IMPORTANT SAFETY RECALL NOTICE

5/19/2011

In cooperation with the U.S. Consumer Product Safety Commission, STIHL Incorporated is recalling certain STIHL Yard Power Tools with Toolless Fuel Caps. These products were sold throughout the United States by STIHL dealers. The STIHL products and model numbers subject to this recall are:

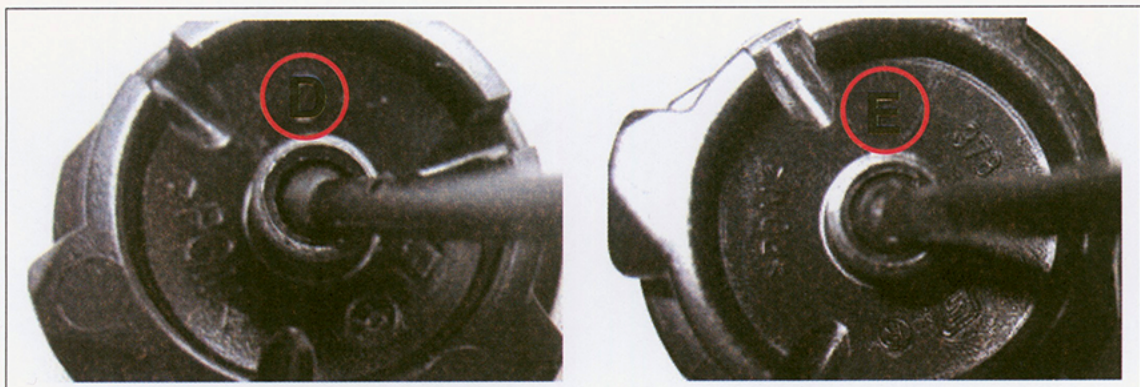
The affected toolless fuel caps can be distinguished from newly designed caps which correct this problem by a molded identifier mark located on the lever of the cap and also by a letter molded on the underside of the cap. These markings are shown in the example photos on the last page of this letter.

Previous
No molded identifier mark

Current
Has molded identifier mark

Previous
Has "D" or earlier index molded
on underside of cap

Current
Has "E" or higher index molded
on underside of cap

As recalled units are returned to you, please replace the existing fuel cap with the new version of the toolless cap. You should also replace the fuel cap on any recalled products in your inventory. **Please note, if the newly designed version of the toolless fuel cap already has been installed on a returned machine, it is not necessary to replace it.**
